HISTORIC AND DESIGN REVIEW COMMISSION

July 19, 2023

HDRC CASE NO: 2023-262
ADDRESS: 250 LAUREL HEIGHTS PLACE
LEGAL DESCRIPTION: NCB 6327 B-2 L-28,29& E 45 OF 27,N 32.58 OF 57&58& N 32.58 OF E 45 FT OF 56 & BLK 2 LOT E TRI 4.16 FT OF 26 & W 5 OF 27 & W 5 OF N 32.58 FT OF 56
ZONING: R-5, H
CITY COUNCIL DIST.: 1
DISTRICT: Monte Vista Historic District
APPLICANT: Mauricio Tafoya/Leon Studio, LLC
OWNER: Benjamin Factor/MILLER S & FACTOR B
TYPE OF WORK: Construction of a 1-story, rear accessory structure
APPLICATION RECEIVED: June 30, 2023
60-DAY REVIEW: August 29, 2023
CASE MANAGER: Edward Hall
REQUEST:

The applicant is requesting a Certificate of Appropriateness for approval to construct a 1-story, rear accessory structure at 250 Laurel Heights Place, located within the Monte Vista Historic District. The proposed accessory structure is to feature 660 square feet.

2 BUILDING ELEVATION - WEST
1/4" = 1'-0"

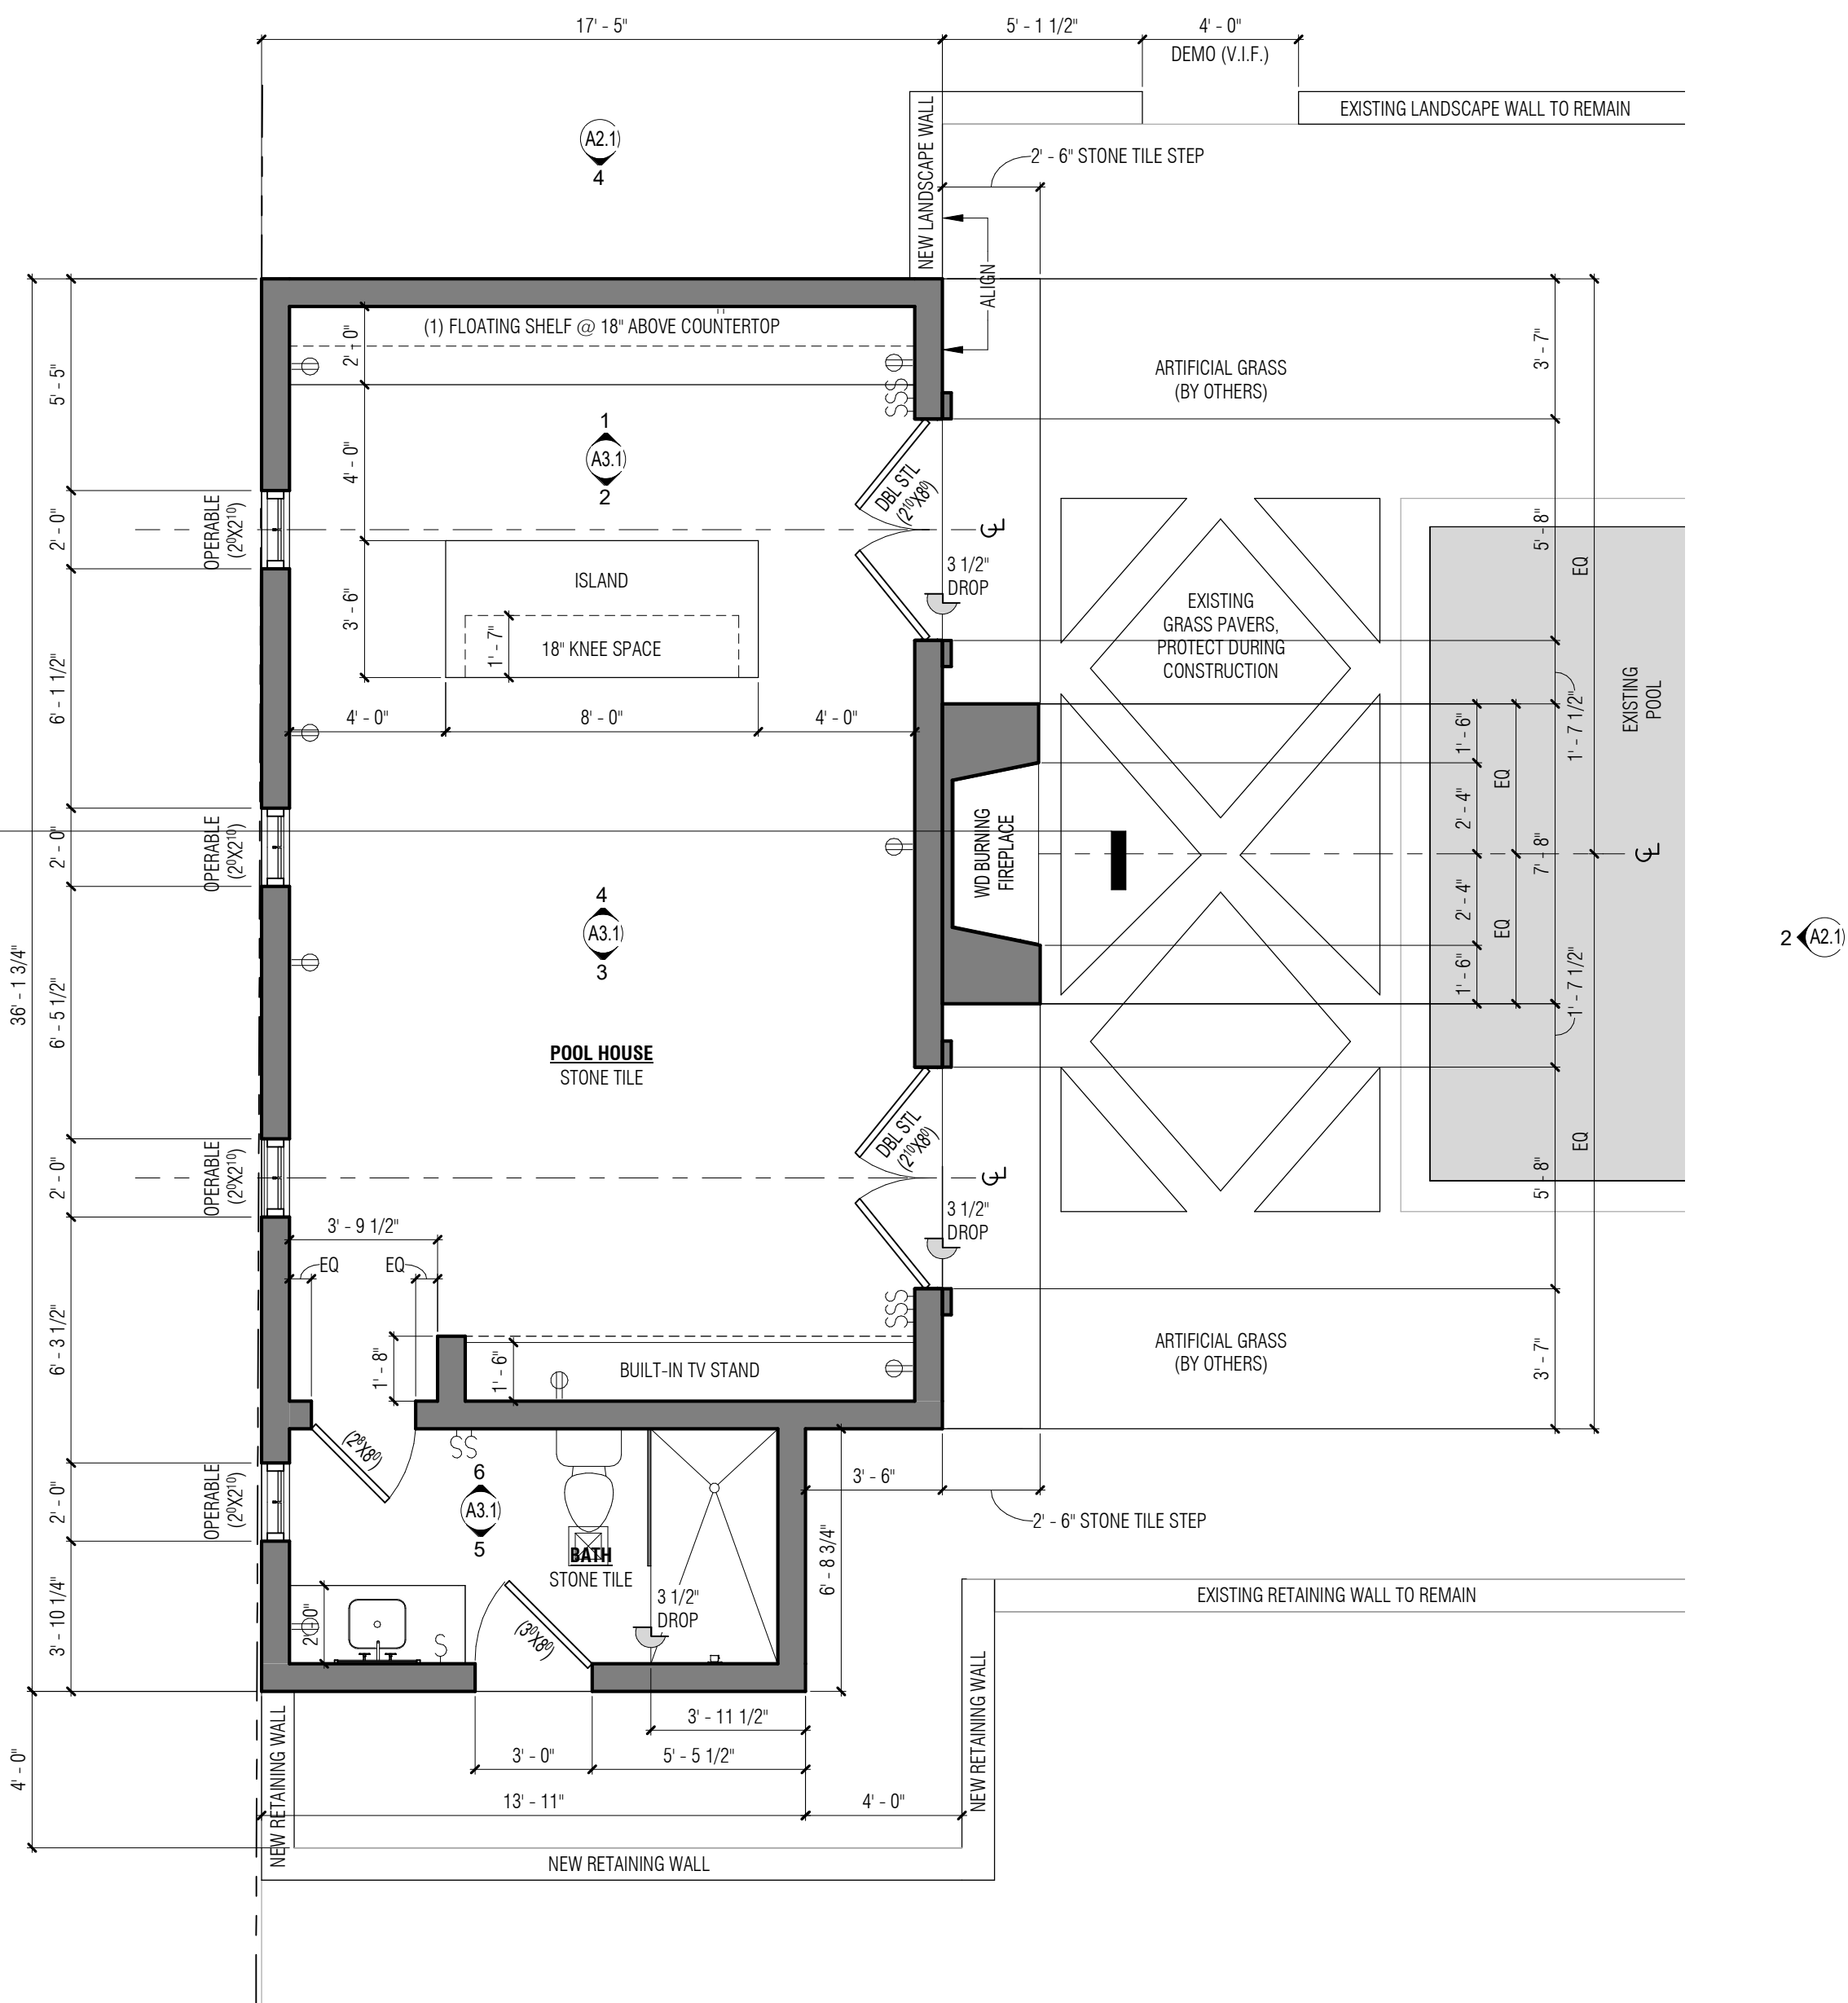
- d. **ACCESSORY STRUCTURE (Massing & Form)** – Regarding overall height, the applicant has proposed for the rear accessory structure to feature one story in height. Staff finds the proposed height to be appropriate and consistent with the Guidelines.

- e. **ACCESSORY STRUCTURE (Orientation & Setback)** – The Guidelines for New Construction 5.B. notes that the predominant accessory structure orientation and historic setback patterns of the block should be followed. Generally, staff finds the proposed location, orientation and setbacks associated with the proposed accessory structure to be appropriate and consistent with both the Guidelines and existing structure's location.

- f. **ACCESSORY STRUCTURE (Materials)** – The applicant has proposed materials that include a clay tile roof to match the existing, steel windows and doors to match those on the primary historic structure, and smooth stucco walls to match the finish of the stucco on the primary historic structure. Staff finds that the proposed steel windows should be consistent with the adopted policy guide regarding finish and installation depth. Windows should not feature faux divided lites or internal grilles.

- g. **ACCESSORY STRUCTURE (Architectural Details)** – The applicant has proposed an overall massing and form and materials that are generally consistent with the Guidelines and the historic architectural forms found both on site and throughout the district.

- i. That the proposed steel windows should be consistent with the adopted policy guide regarding finish and installation depth. Windows should not feature faux divided lites or internal grilles.
- ii. That product specifications be submitted to OHP staff for review and approval for the proposed roof tile and windows.
